TECHNICAL SERVICE BULLETIN

2022-2024 Expedition/Navigator - Random Blind Spot Information System (BLIS) Warning With No Vehicle Or Objects Near Vehicle

24-202808 March
2024

This bulletin supersedes 23-2266. Reason for update: add 2024 vehicles.

Figure 3

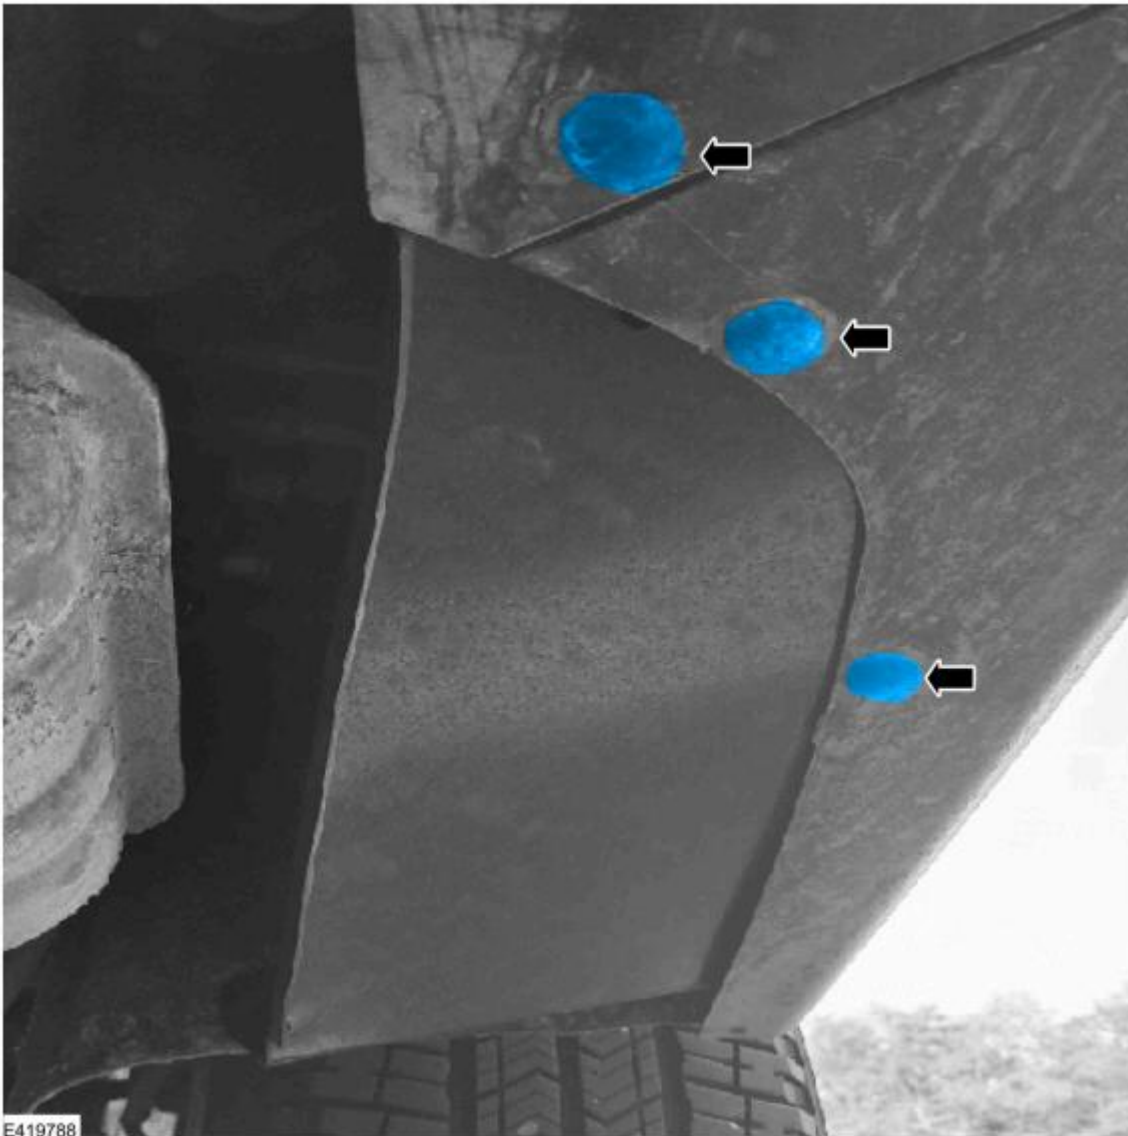
9. Remove the 6 push pin retainers (3 per side) at the bottom of the rear bumper cover. (Figure 3)

Figure 6

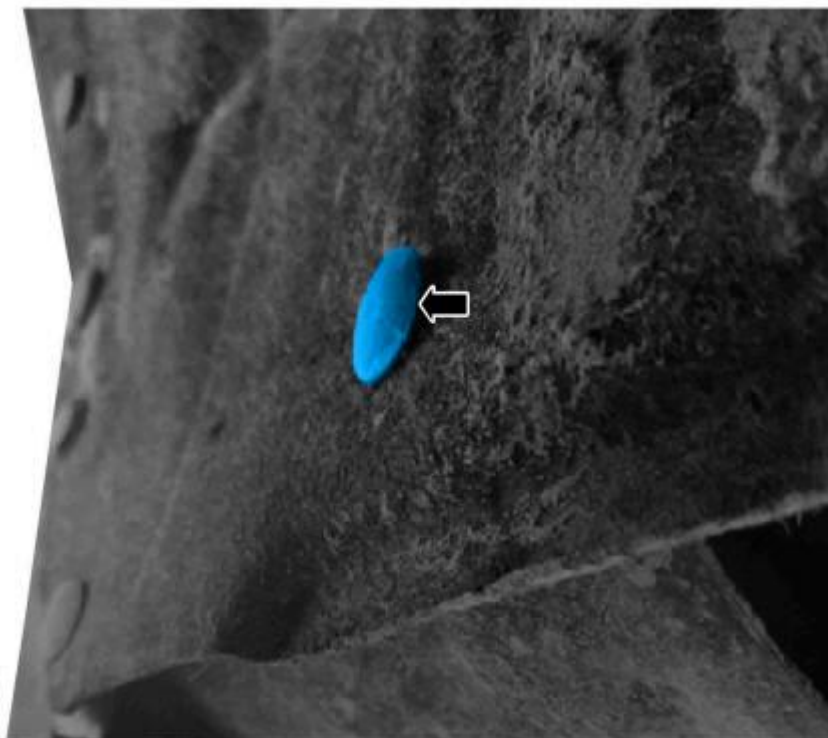
- 12.** Remove the new shields.
- 13.** Using a 6 mm (1/4 in.) drill bit, drill holes in the previously marked locations.
- 14.** Install the new shields.
- 15.** Install the 6 push pins removed in Step 5.
- 16.** Install the additional push pins in the new hole locations. (Figure 6)
